THE PROPOSED DEVELOPMENT OF A "NEW RETREAT" ON A PORTION OF PORTION 11 OF FARM 1674, PAARL
CHAND REFERENCE NO: 03005
DEA&DP Pre-Application Reference Number: 16/3/3/6/7/1/B4/12/1086/20
DWS Reference: WU17609

**FIRST PRE-APPLICATION MEETING WITH THE DEPARTMENT OF WATER
& SANITATION**
KEY NOTES_FINAL

PRE-APPLICATION MEETING WITH THE DEPARTMENT OF WATER & SANITATION
KEY NOTES_FINAL

Figure 2 Proposed Services with freshwater layers indicated

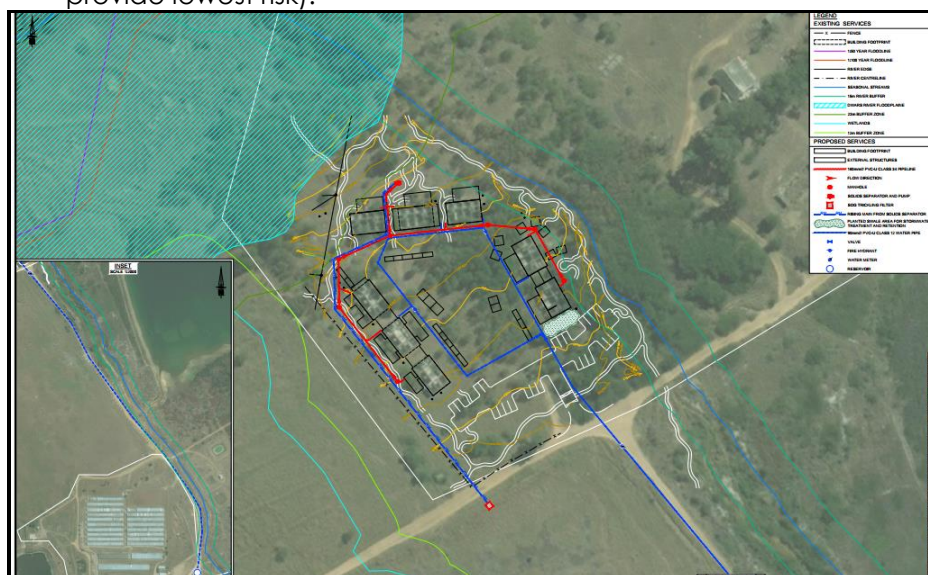
- b) Regarding proposed services, MP indicated that new water and sewer lines would need to be installed, and the existing septic tanks and soakaways on site (of which there are two) would not be used. She added that alternatives have been assessed in terms of routing of lines and the preferred alternative is indicated in Figure 2 (the plan was provided in the meeting) and had been devised to be low risk to the watercourses and to locate the infrastructure as far away from the watercourses as possible.

- c) MP added that the intention would be to use a small sewage package plant that would treat wastewater to general limits. Sewage from each unit would flow via gravity feed to a pump in the north-west corner of the site, and then be pumped to a treatment component across the ou wapad to the south-west of the site (deliberately located as far from the watercourses as possible).

- d) MP added that there are presently a few options for discharge of the treated wastewater under consideration and that advice from the Department of Water and Sanitation (DWS) in this regard would be appreciated. These could be into the toilets for flushing, or irrigation (noting that the freshwater impact assessment report had indicated that use of treated water for flushing would be preferable and would then not trigger Section 21 (e) and (g), but if irrigation must be carried out with the treated wastewater, irrigation of areas alongside the road would provide lowest risk).

Figure 4 Watercourses along water line to reservoir (note line would be within existing road)

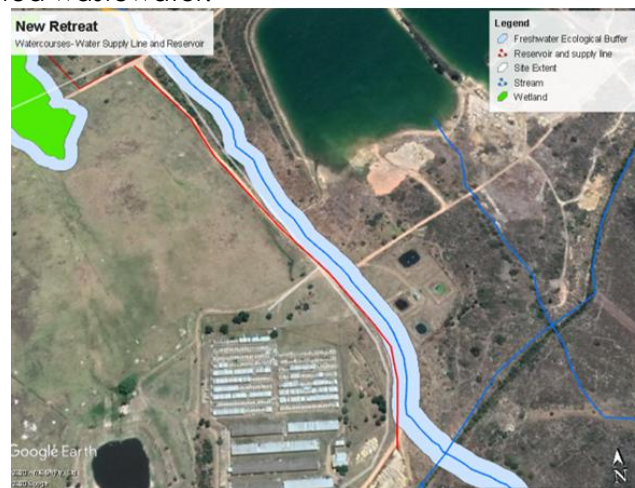
- f) MP added that there is a stream alongside the site, as well as two wetlands nearby, and the proposed water line to reservoir tanks would be within the road, but would run alongside stream 10 (refer to Figure 3 and Figure 4).
